Serial No. 17-325
Docket Nos.: 50-338/339
50-280/281
52-017
72-2/16/55/56

Proposed Changed NAPS Emergency Plan Pages

Title: North Anna Power Station Emergency Plan

Revision # TBD updates this entire document. Revised material includes, but is not limited to:

STATION TO SUPPORT GROUP INTERFACE
PRIOR TO AUGMENTATION OF THE ONSITE EMERGENCY ORGANIZATION
FIGURE 5.3

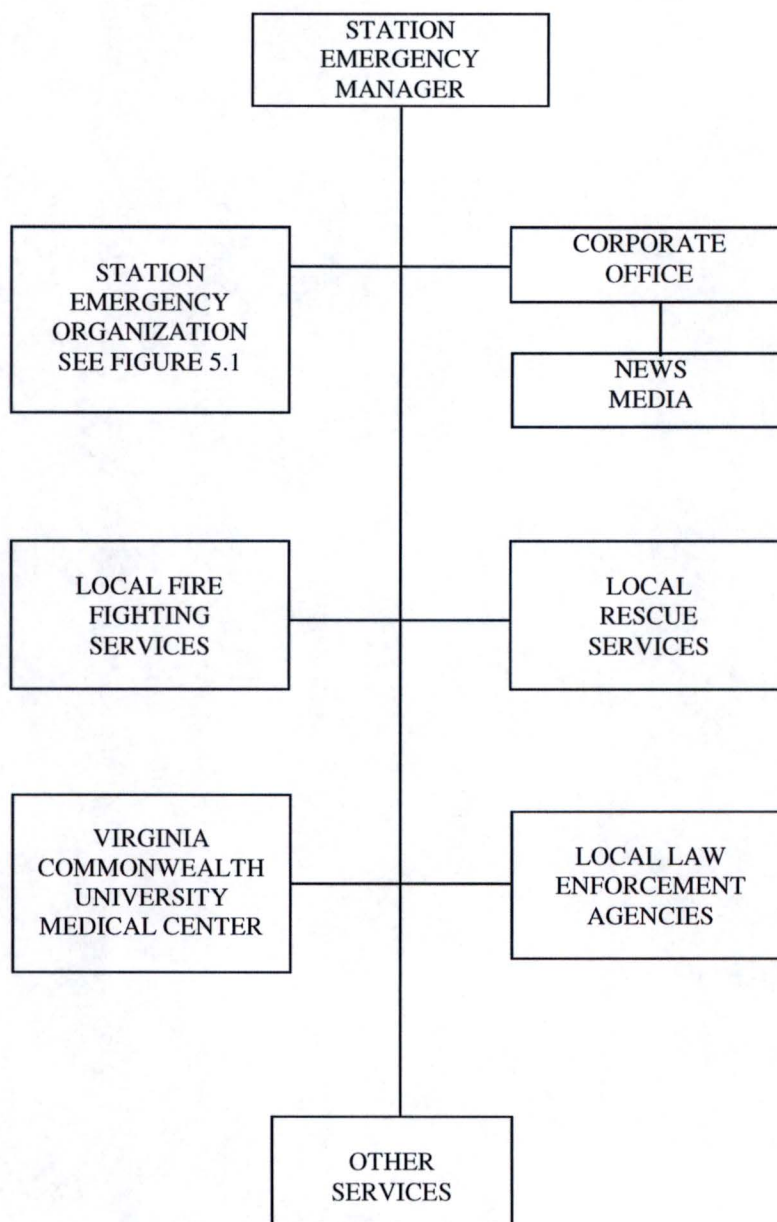
*** Transferred to LEOF-CERC when facility activated.

STATION TO SUPPORT GROUP INTERFACE
FOLLOWING **LEOFCERC** ACTIVATION
FIGURE 5.4

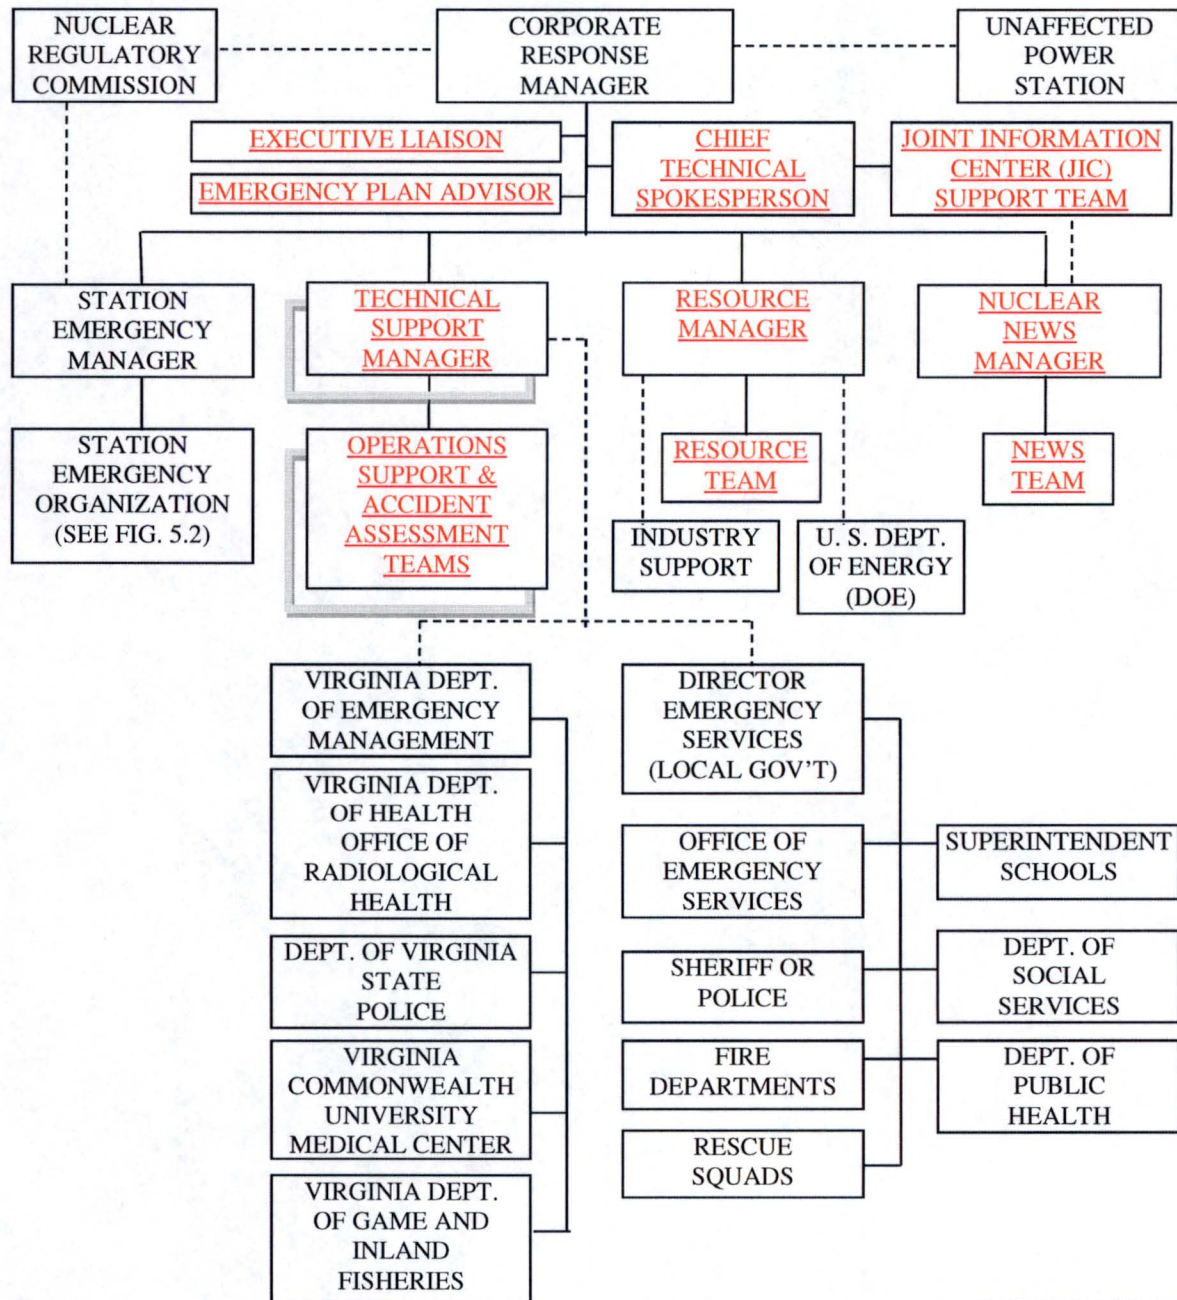
SHADED BOX IDENTIFIES
SUPPLEMENTAL STAFFING
WHEN CERC SUPPORTING
SURRY AND NORTH ANNA

FIGURE 9.1

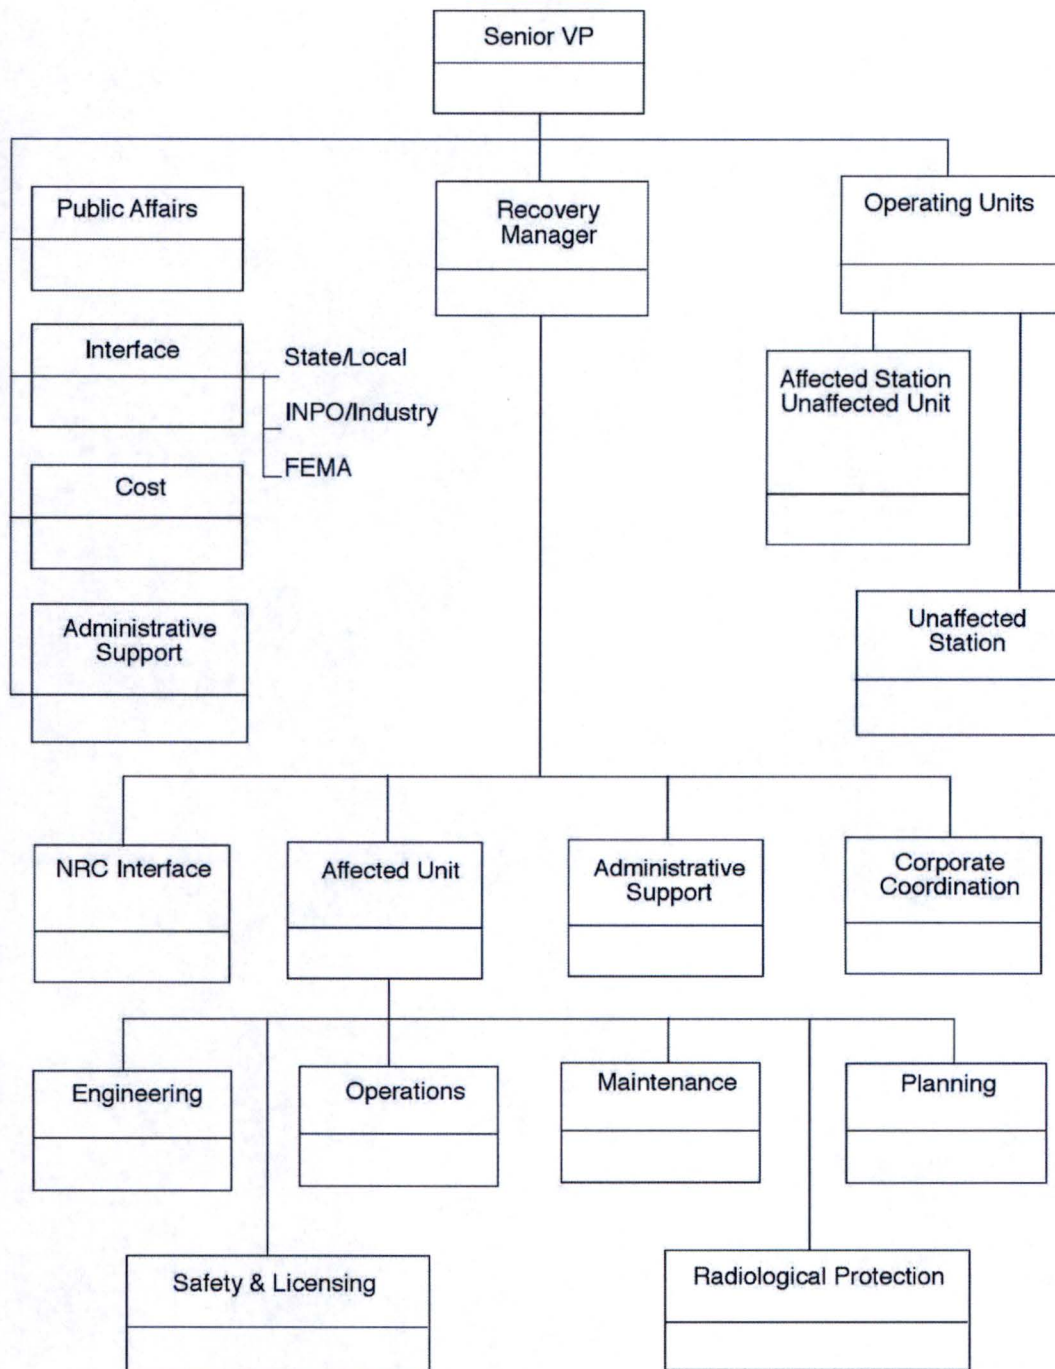
The recovery process will be managed by a special, designated organization composed of Dominion personnel. The recovery organization is described in ~~the Corporate Emergency Response Plan~~ Figure 9.1. The basic organization may be modified as required to address the needs of the given situation. The ~~Recovery-Technical Support~~ Manager assumes control and direction of the recovery operation with the authority and responsibilities for implementing and administering the recovery plan and organizations set forth in the Corporate Emergency Response Plan. Responsibilities of the recovery organization include defining recovery objectives, developing a plan to accomplish these objectives, establishing controls and anticipating potential complications, monitoring the recovery effort and adjusting the plan accordingly, and evaluating accomplishments against the designated objectives.
